Kenya Bureau of
Standards

OUR REF: KEBS/T028/2023/2024

ADDENDUM NO.1 TO TENDER NO. KEBS/ KEBS/T028/2023/2024 - SUPPLY, DELIVERY, INSTALLATION, COMMISSIONING AND USER TRAINING OF MOTOR VEHICLE INSPECTION EQUIPMENT

Annex 1(proposed layout of the inspection center)

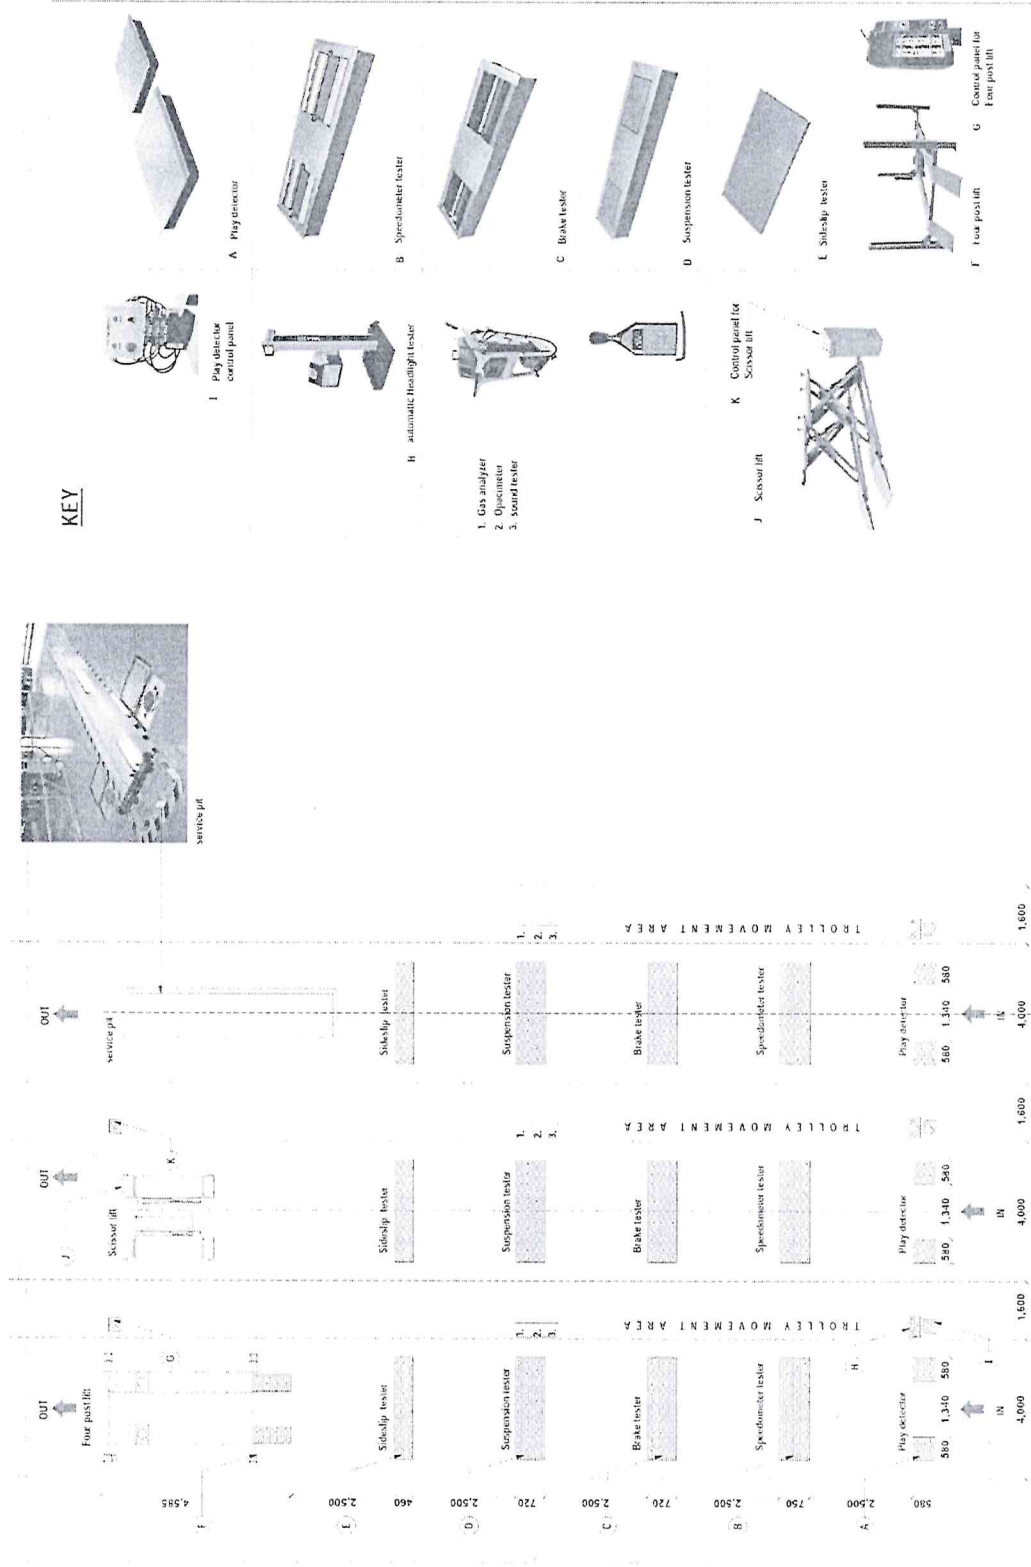
<p>2</p>	<p>2. The 2nd topic that is cause for concern is that the KEBS team advised that the tender requirement includes the civil/building works for the in-ground test bench equipment. Civil/building works are not mentioned anywhere in the tender document, so this came as a surprise.</p>	<p>i. Civil works will be undertaken by a different contractor. However successful bidder for this tender will be called upon to give advice on how the ground will be set.</p>
<p>3</p>	<p>3. Having visited the Naivasha site today, we see that the facility does not seem to allow for vehicles being tested to drive through (in on one side and out on the other side). This is going to severely affect and complicate the efficiency of the test centre.</p>	
<p>4</p>	<p>4. Finally, we saw the carpark area outside, and noticed that the surface consists of industrial stones (small rocks). Should these stones lodge into vehicle tyres, and then be dropped into the moving parts of the test benches, this will also negatively affect the longevity of the equipment. We have experience with this challenge.</p>
